Re: Burger King
7101 Lomas Blvd. NE
Traffic Circulation Layout
Architect's Stamp 01-31-23 (J19-D052)

Based upon the information provided in your submittal received 05-01-23, the above referenced plan cannot be approved for Building Permit until the following comments are addressed:

TCL

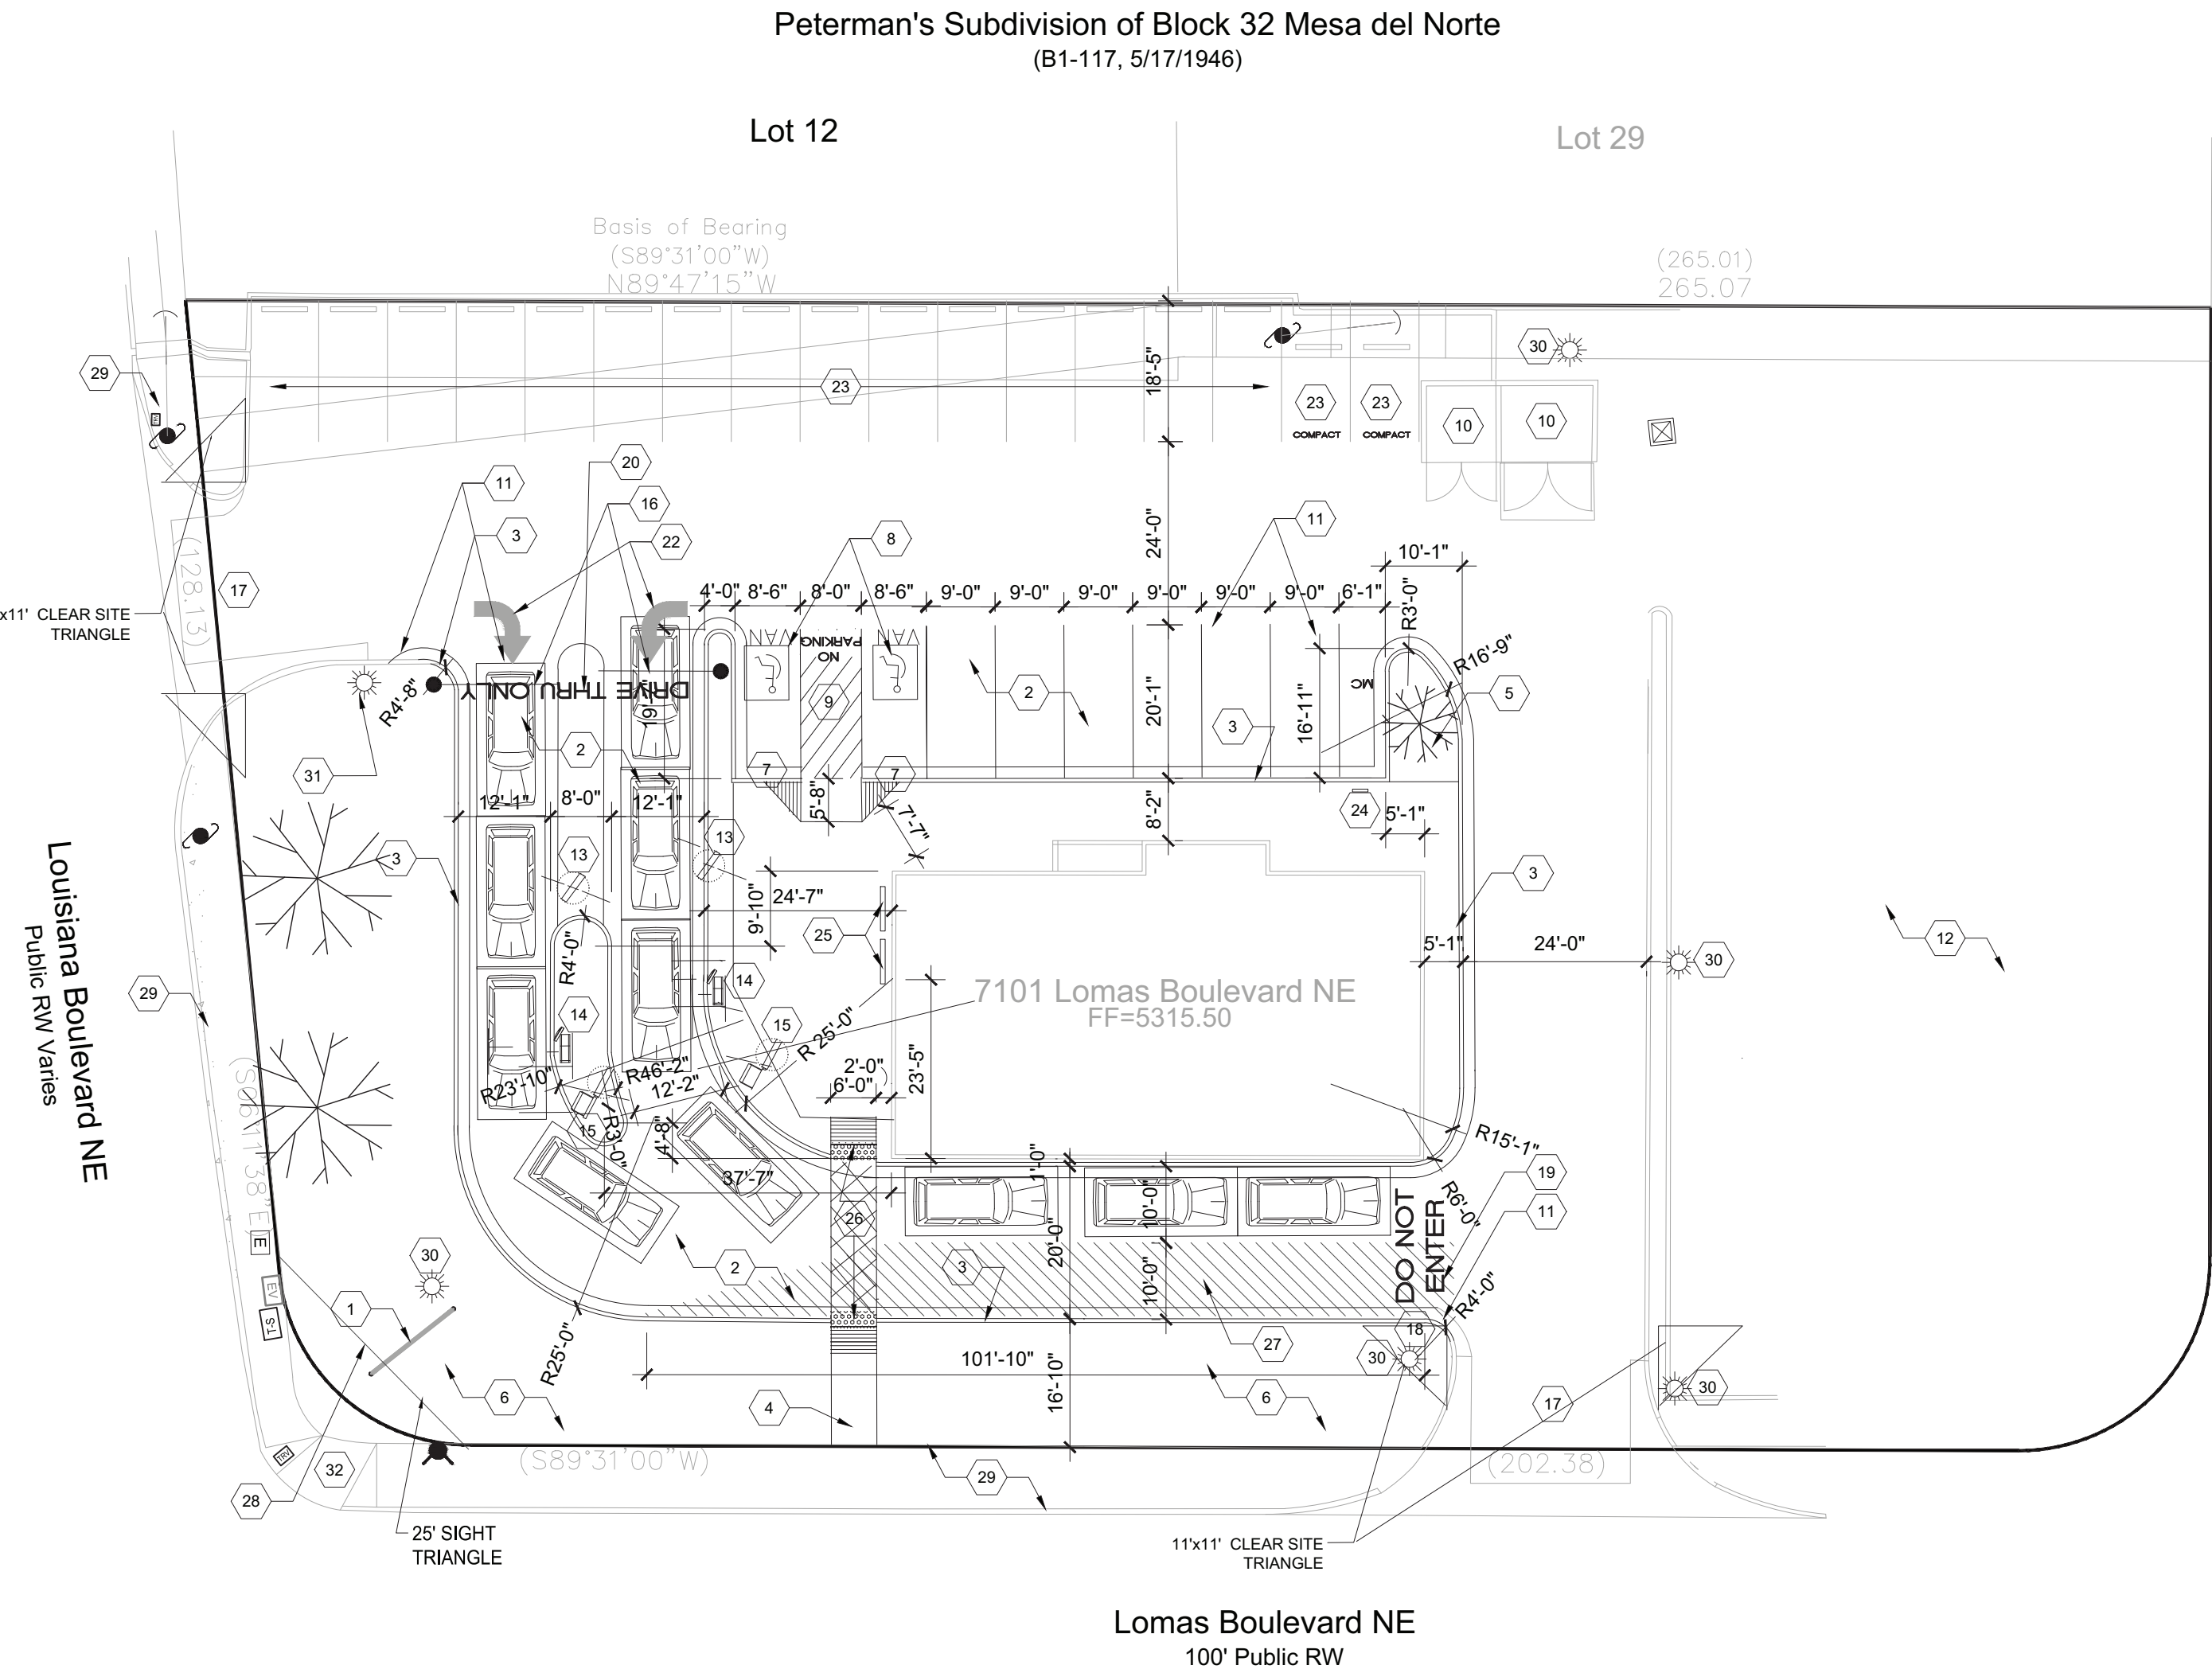
1. Identify all existing access easements and rights of way width dimensions.
2. Please provide dimensions for the existing parking spaces at the north side of the site.
3. ADA curb ramps at both site accesses must be updated to current standards and have truncated domes installed.
4. Keynote 4 & 26: Please define ADA pathway from the public sidewalk to the building entrance by labeling flush, or ramps, and provide the width.
5. Site access off Louisiana: A minimum 4-foot wide pedestrian pathway should be shown around each existing pole. Please show this dimension on the site plan to ensure that a minimum 4-foot wide path is obtained.

6. Please provide "ONE WAY" and "DO NOT ENTER" signage at the beginning and the exist of the drive-thru lane.
7. 12 ft. is the minimum drive-thru lane width. Please revised the site plan.

8. Please specify the City Standard Drawing Number when applicable.
9. Please provide a letter of response for all comments given.
10. Traffic Studies: See the Traffic Impact Study (TIS) thresholds. In general, a minimum combination of 100 vehicles entering and exiting in the peak hour warrants a Traffic Impact Study. Visit with Traffic Engineer for determination, and fill out a TIS Form that states whether one is warranted. In some cases, a trip generation may be requested for determination (**Contact Matt Grush: mgrush@cabq.gov**)
